November 27, 2013

RFB NO. 313086 - ADDENDUM NO. 4

ARCTIC ANIMAL EXHIBIT AND CONCESSIONS

6. Sheet SR1.3- Bear Pool Wall Plan

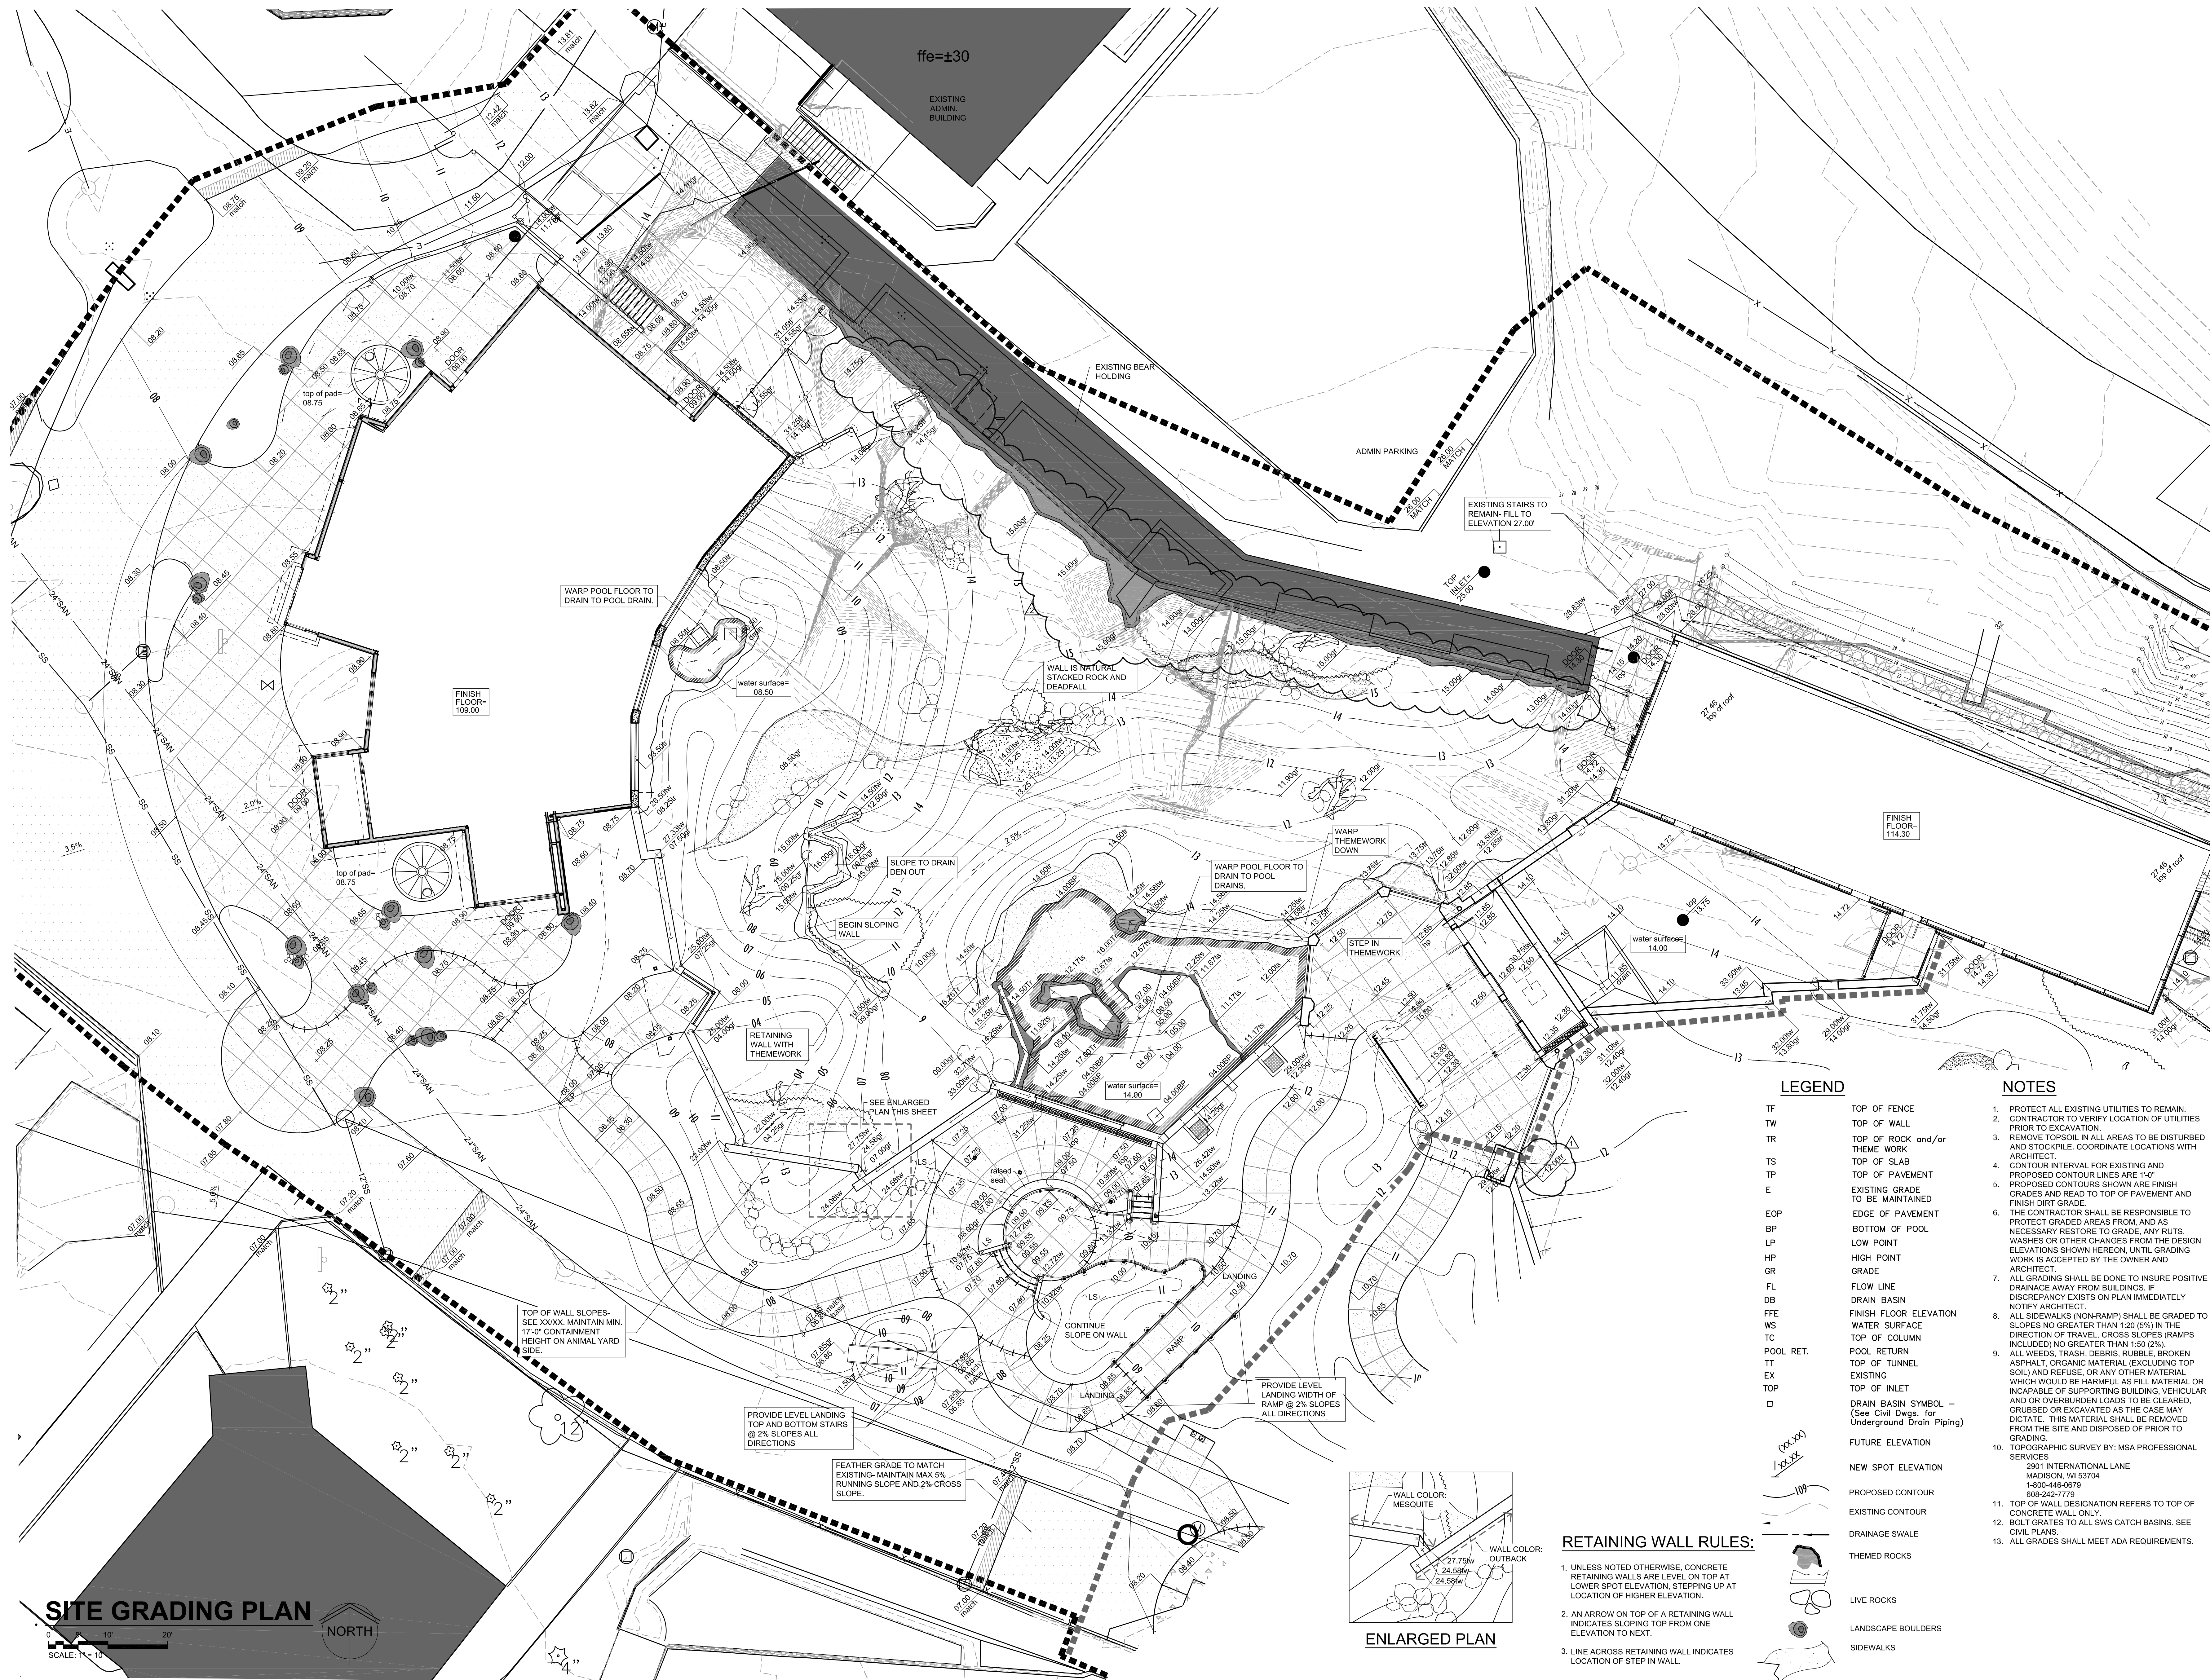
- Foundation lines at the pool depth change should be flipped to opposite side of the pool wall to match detail 8/S7.4

SG1.1
11/27/2013 10:28:09 AM
WDM Architects P.A.

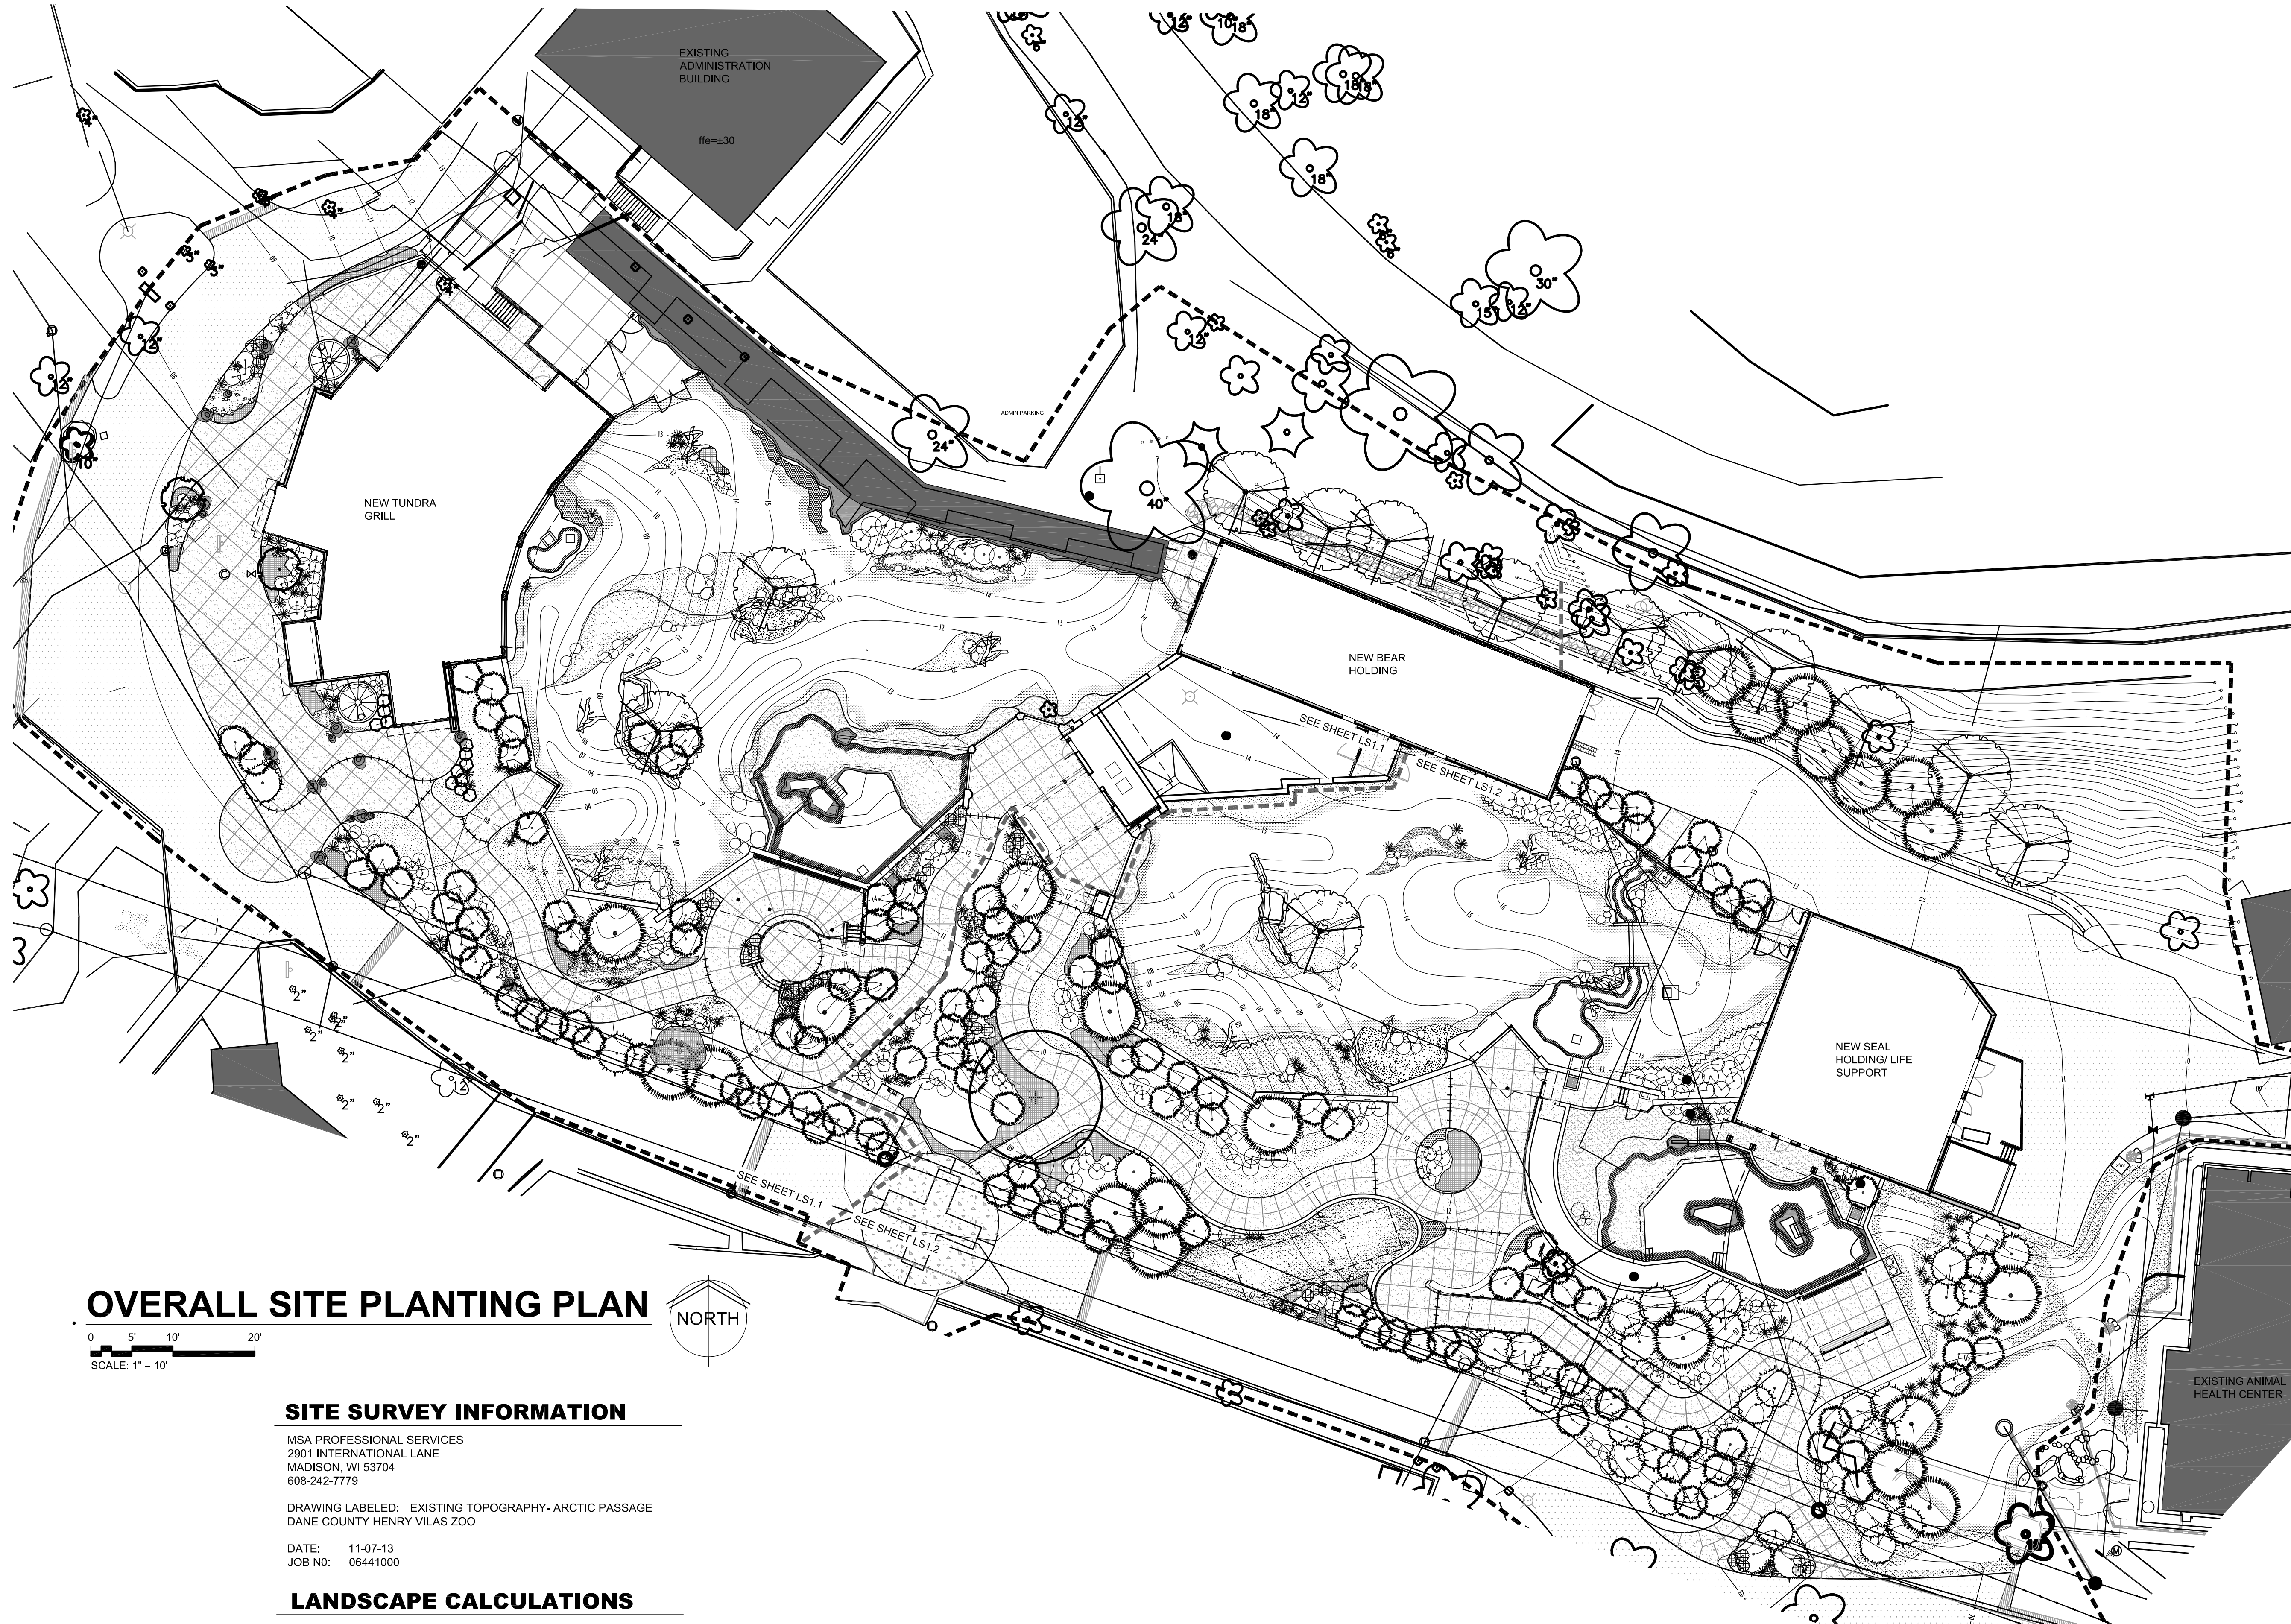
- Added spot grades at existing tunnel/back wall of polar bear yard

ST1.1

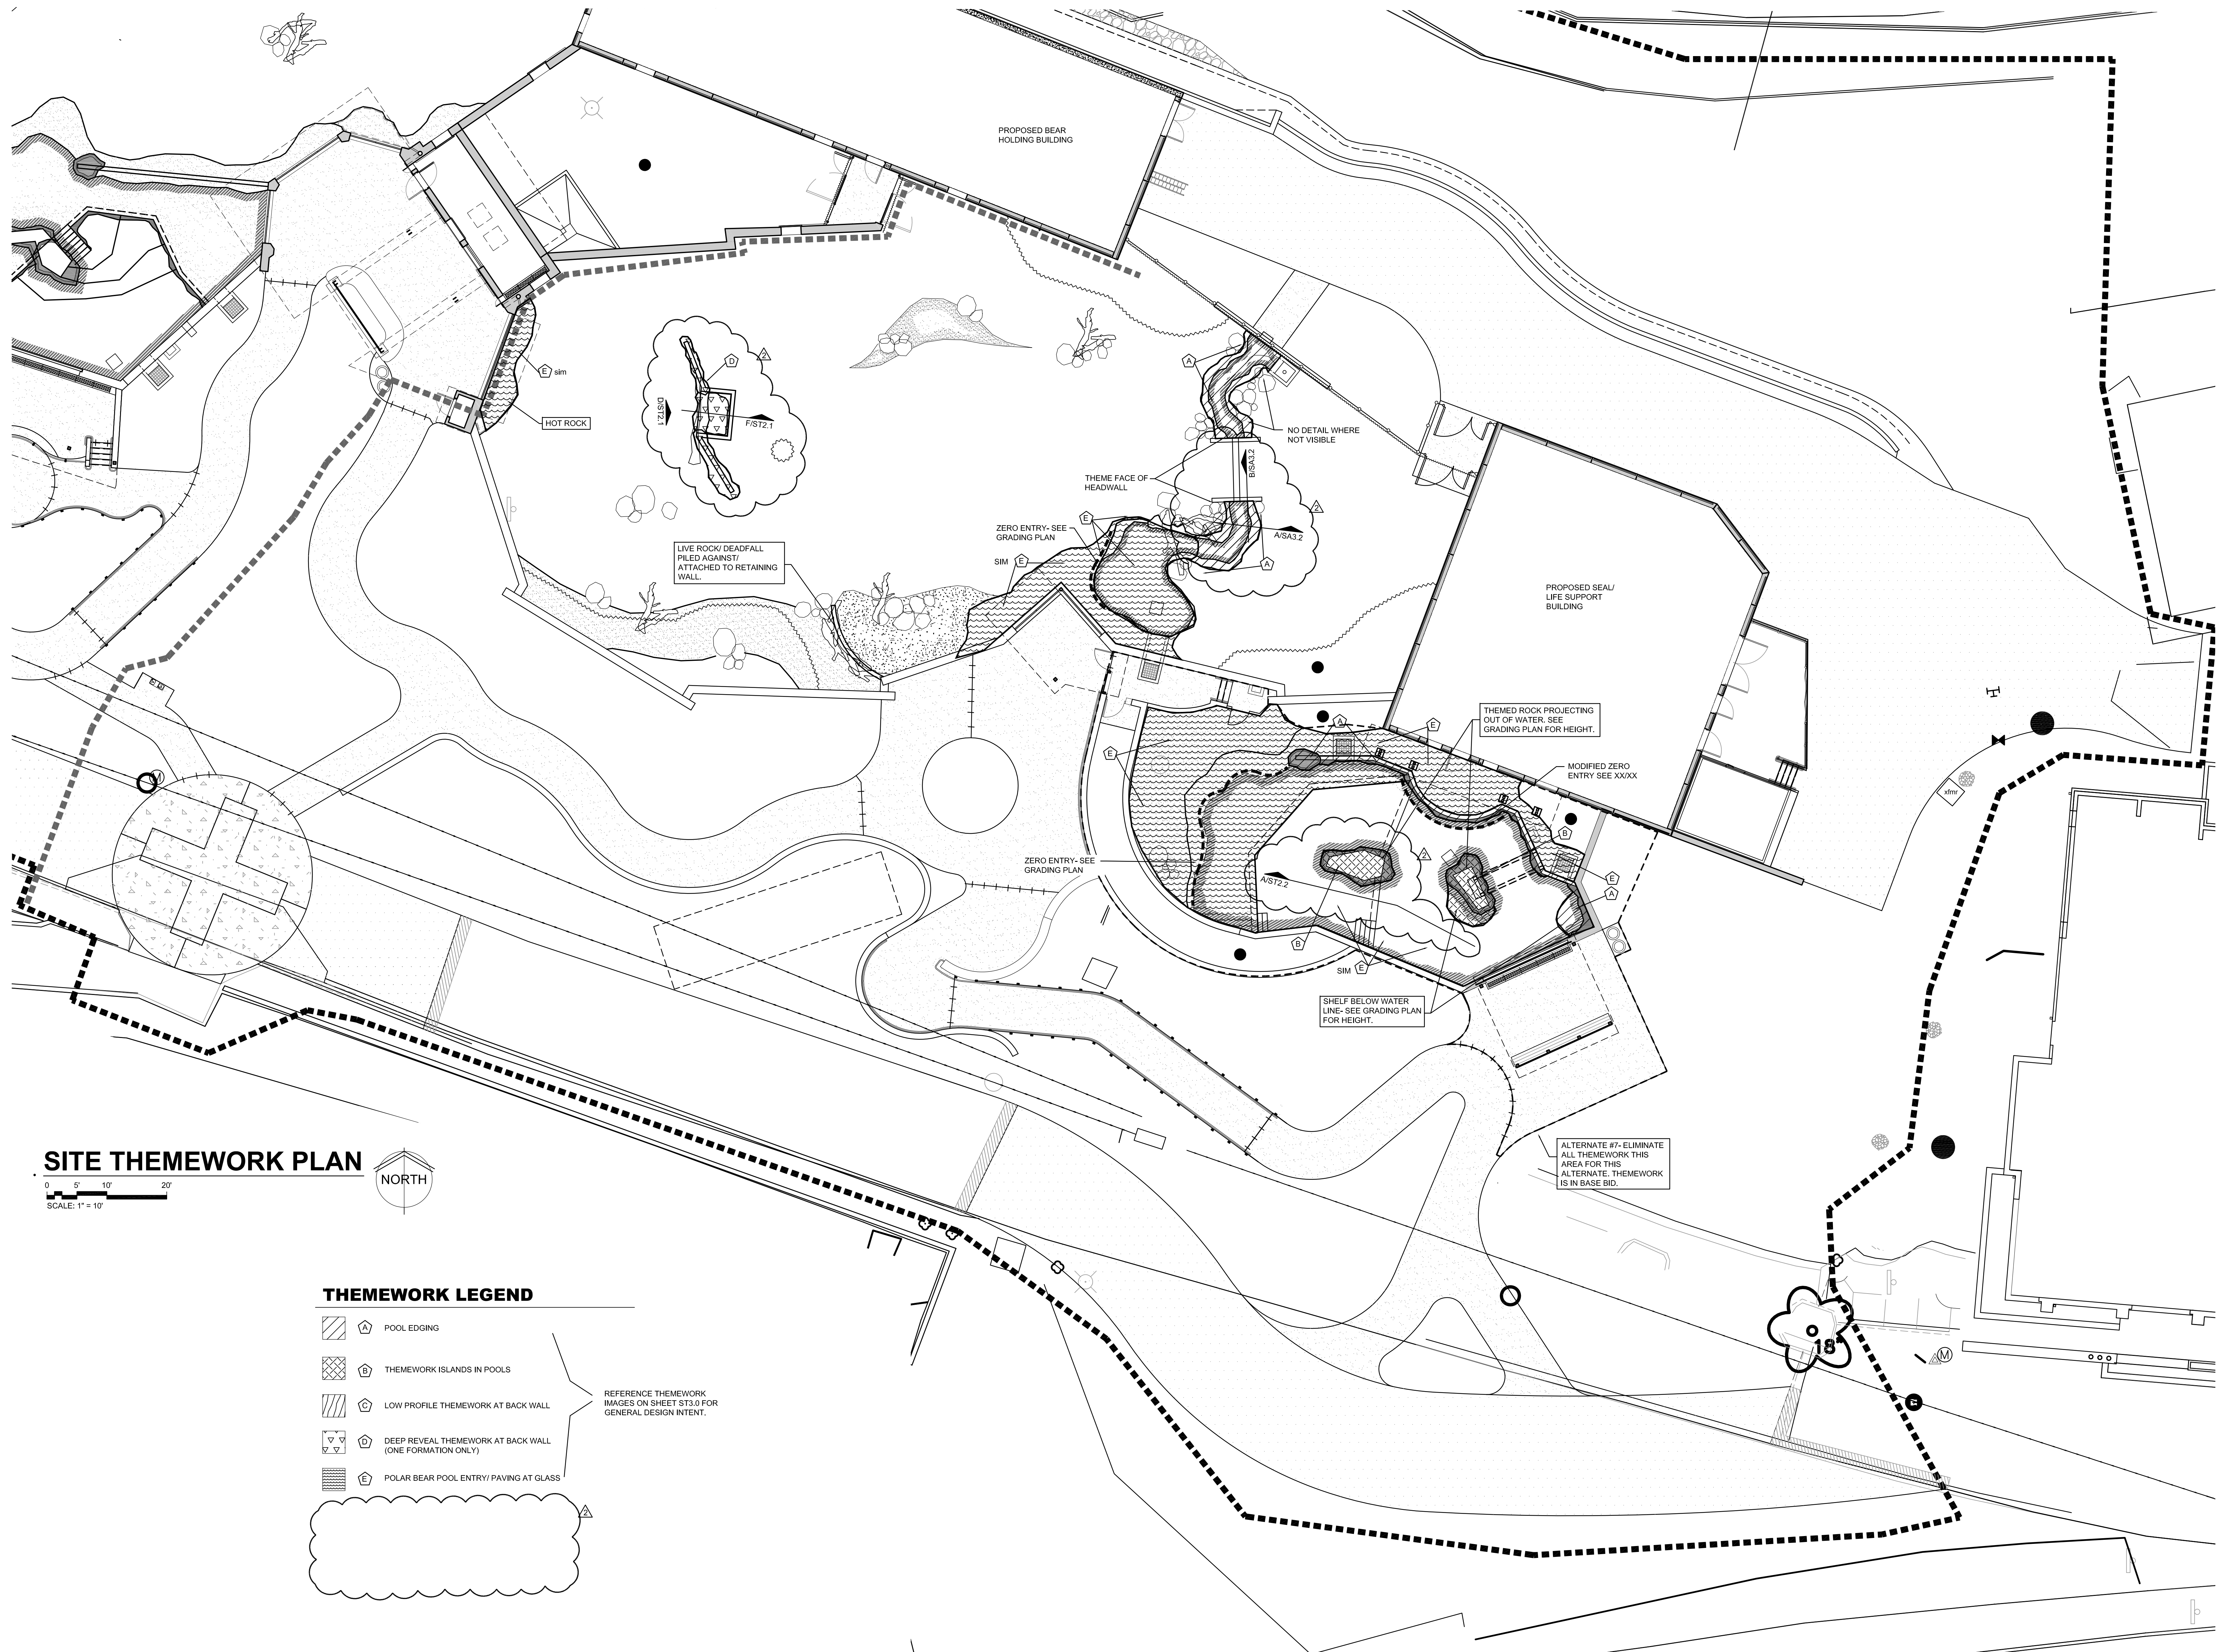
- Updated references to themework sections/ elevations
- Eliminated the 6th (last) themework type from the legend
